UNITED STATES PATENT AND TRADEMARK OFFICE

APPLICATION NO.	FILING DATE	FIRST NAMED INVENTOR	ATTORNEY DOCKET NO.	CONFIRMATION NO.
09/773,036	01/31/2001	Joseph M. Probst	04645.0558	5492

Office Action Summary	Application No.	Applicant(s)	
	09/773,036	PROBST ET AL.	
	Examiner	Art Unit	
	Gregg Cantelmo	1745

DETAILED ACTION

FIG. 6

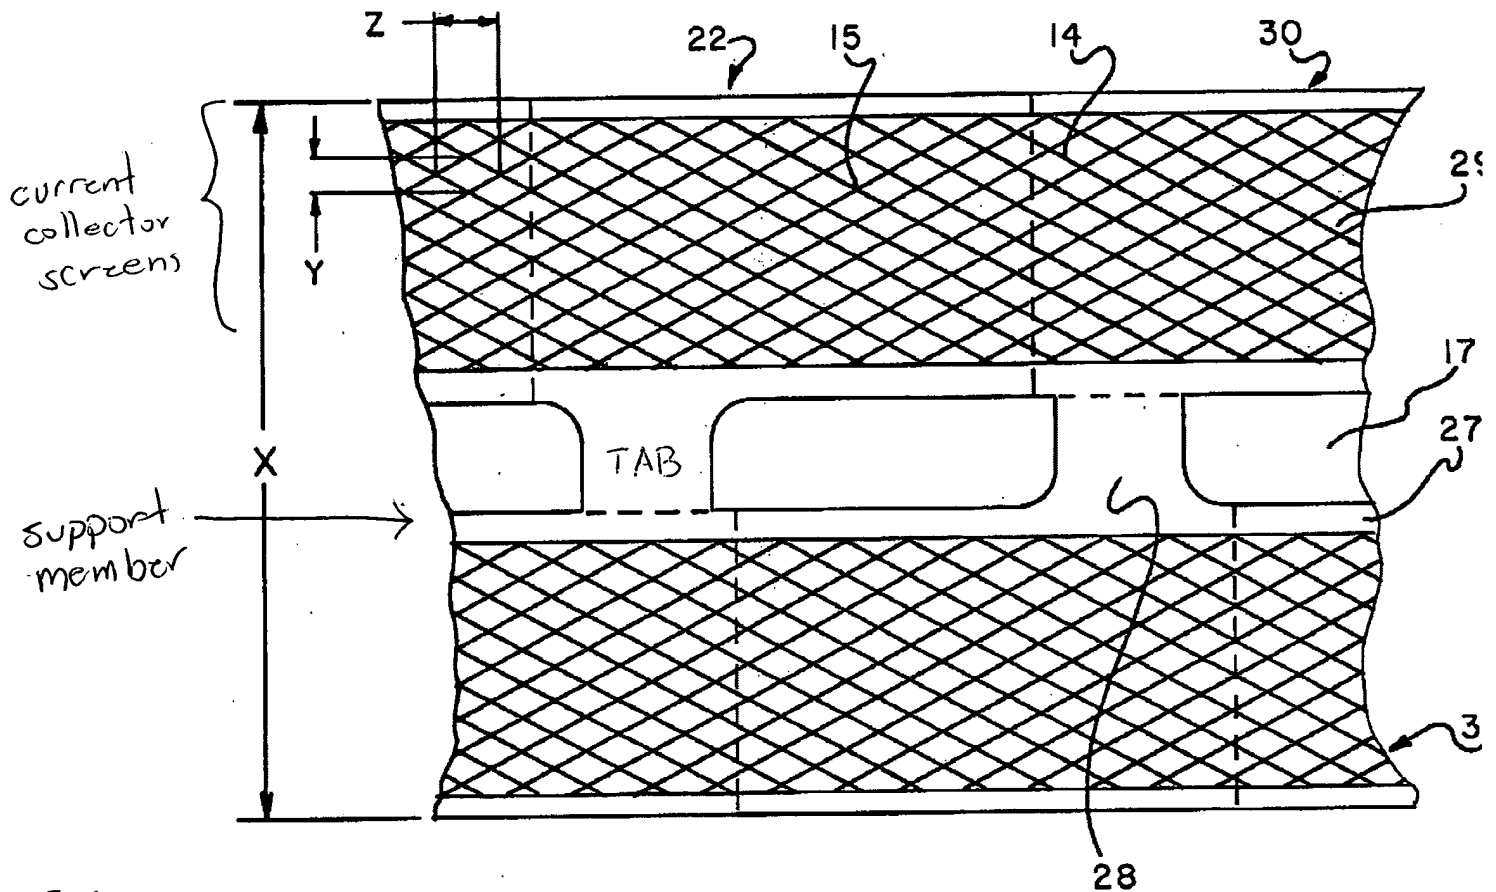
McDowell discloses a common carrier comprising: an elongate support member having a plurality of locating holes 17 disposed thereon, a plurality of current collector screens 29 integrally formed with and extending from a portion of the central support member 30 (Fig. 6 as applied to claim 1). See marked-up Fig. 6 below.

Loewen discloses a common carrier comprising: an elongate planar central support member having at least one datum (holes 17), a plurality of current collector screens 29 integrally formed with and extending from a portion of the central support member (Fig. 1 as applied to claim 5). See marked-up Fig. 6 below.

The current collector screens 29 are connected to the central support member through respective external tabs 28 (Fig. 1 as applied to claim 6).

The external tab 28 connects at a substantially perpendicular orientation with the central support member (Fig. 1 as applied to claim 7).
